EPA Response to Comments for NPDES Permit No. NH0100790
("Response to Comments")

**RESPONSE TO COMMENTS
NPDES PERMIT NO. NH0100790
KEENE WASTEWATER TREATMENT PLANT
KEENE, NEW HAMPSHIRE**

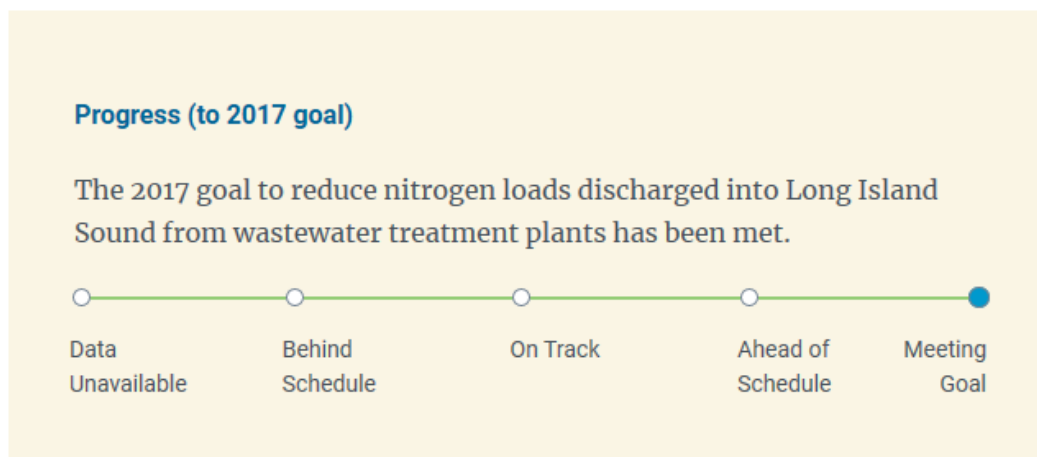
Table 3 of the Fact Sheet of the Draft Permit presents the methodology used to assess Annual Average Total Nitrogen limitations for NH WWTFs in the LISW. This methodology appears without science-based support. Specifically:

- There is no background data provided within the Draft Permit indicating why a Total Nitrogen concentration was selected or why a specific concentration or alternate optimization or monitor-only requirement is imposed.

- There is no indication that a specific Total Nitrogen concentration will provide a specific outcome to the LISW. The LISW TMDL and associated WLA do not indicate that such numeric Total Nitrogen concentrations from NH WWTFs are required, nor that the baseline loadings and associated 25% aggregate reduction is impacted by this numerical permit limitation.

The General Response in Appendix A describes the necessity of the nitrogen limit and EPA's process for calculating it, as well as issues relating to cause and effect, which is not a demonstration that EPA needs to make prior to imposing a protective effluent limitation.

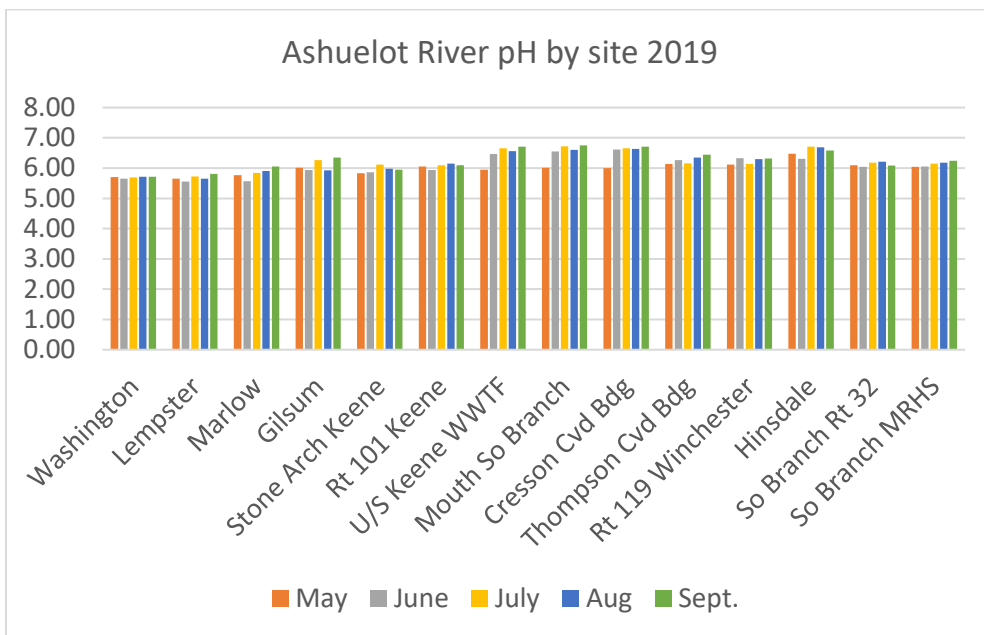
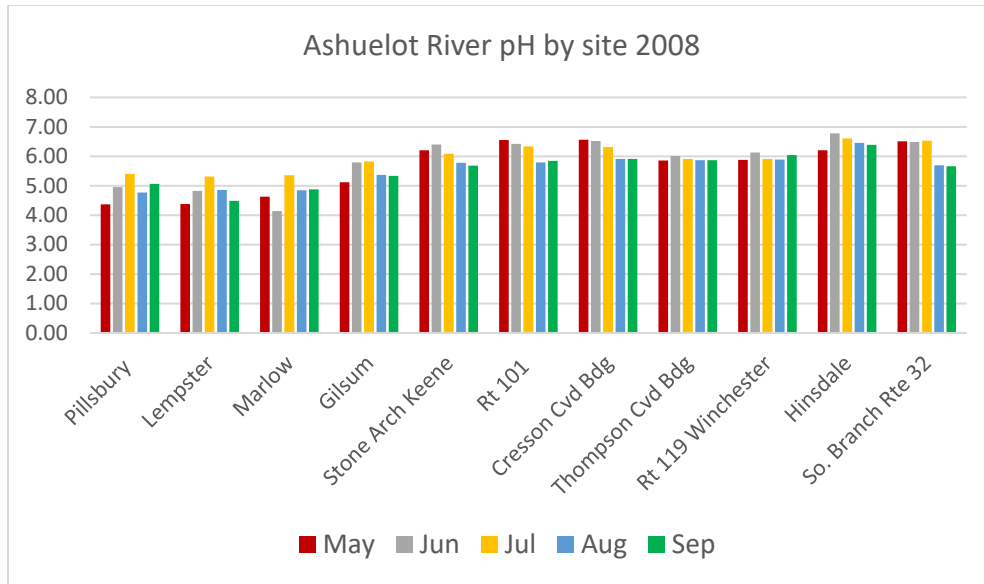
The Ashuelot River continues to be listed as impaired for low pH. The trend shows a lower pH in the upper reaches of the River upstream of Keene, but with readings increasing as the River flows through and downstream of the City. Following are charts showing the values obtained during our 2008 and 2019 monitoring seasons.

Over the years the pH of the Ashuelot River has been slowly trending closer to the NH WQS of 6.5-8, the cause for this increase remains debatable. As the WQS provides the optimum range for aquatic life and the Ashuelot has been slowly approaching this standard, ARLAC supports the continuation of its application to the Keene WWTP as a basis for pH limits.
